### Changes in topside tank configurations that you need to know going forward!!

The new EPA Evaporative Emissions Regulations require Moeller as a fuel tank manufacturer to make several changes to our above deck topside tanks above 12-gallon in capacity to accommodate boats built after 2011:

031615 / 031615BR

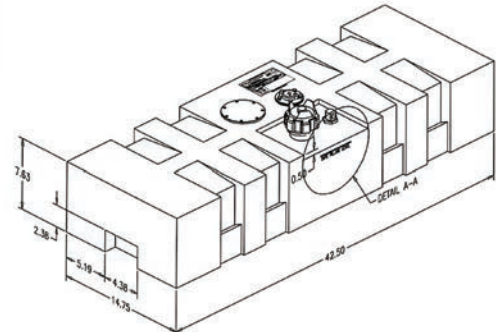
The attached line drawings detail the changes we've had to make.
